Attachment 3. DOE/LANL has used improper fluid-assisted drilling methods that mask detection of groundwater contamination for the installation of the LANL characterization wells that are planned to be used as monitoring wells.

As-Built Schematic for LANL Characterization Well R-16

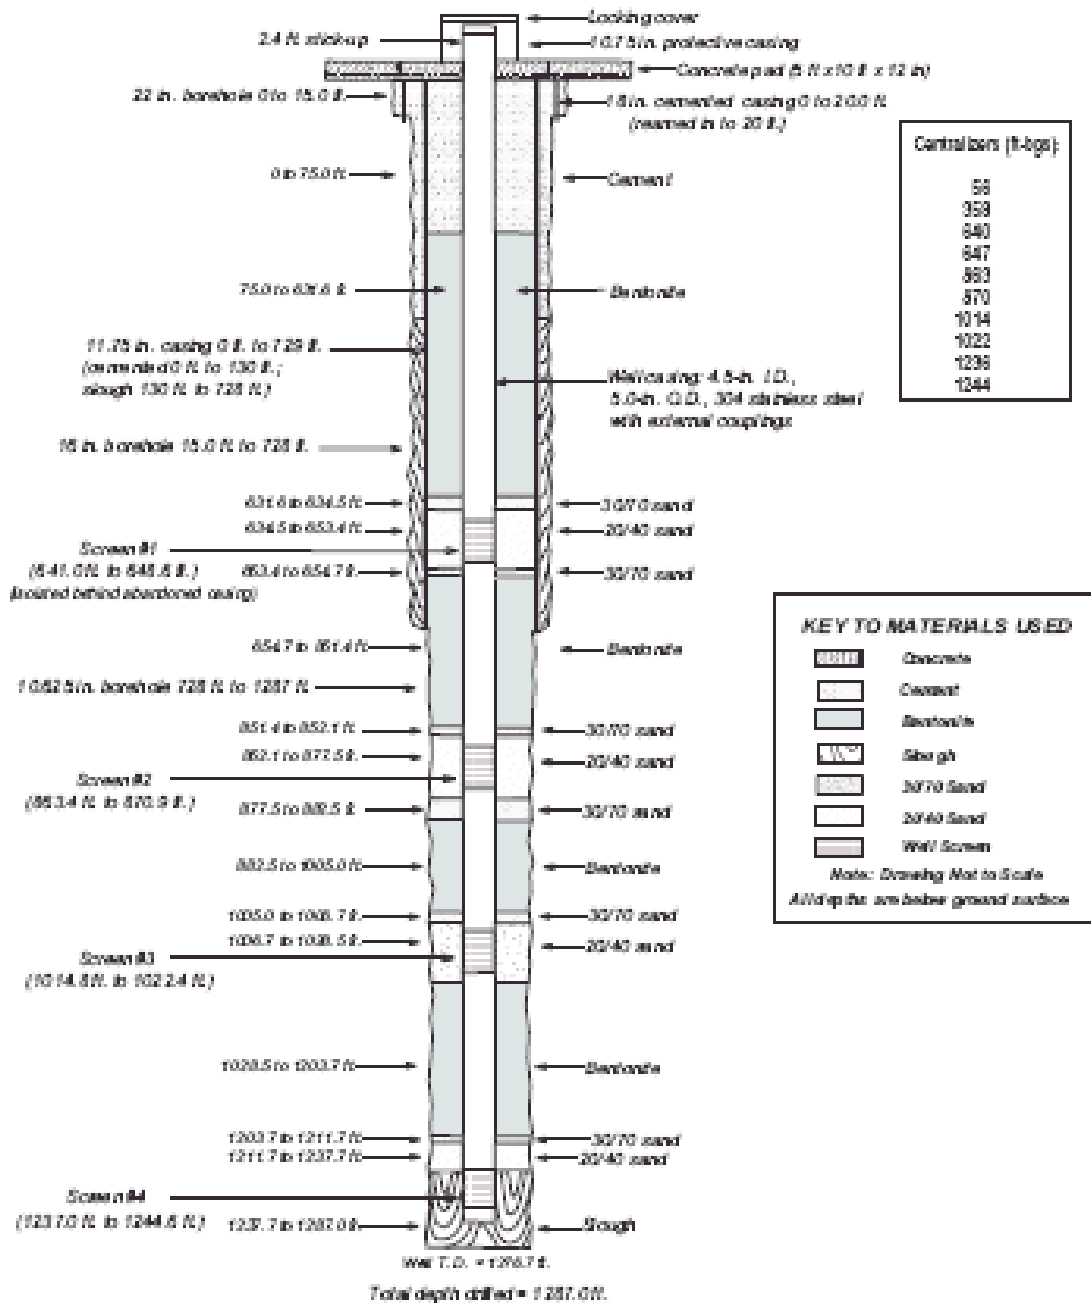
The as-built schematic for well R-16 is shown below. The retractable drill casing that was abandoned in the borehole blocks off screen #1. Screen #4 does not produce representative groundwater samples because the screen is surrounded by bentonite clay slough sediments that were not cleaned from the borehole before the well was constructed. None of the well screens produce reliable and representative water samples because of the mud-rotary drilling method that invaded the screened intervals with organic and bentonite clay drilling fluids.

Further, the use of the no-purge Westbay[®] water sampling equipment collects stagnant water samples from the screened intervals. The regulations require that a continuous flow of water is produced from the well to determine that representative samples are collected from the in-situ groundwater. The Westbay[®] equipment does not allow for the purging of the large quantities of water that are required by the regulations.

An additional problem is that the Schlumberger[®] borehole geophysics report, included as an appendix in the LANL Well R-16 Completion Report, shows that the well screens are not installed in the strata with highest permeability, the aquifer strata that are the fast pathways for contaminants to travel to the Buckman Wellfield. There are many factors that require replacement of Well R-16.
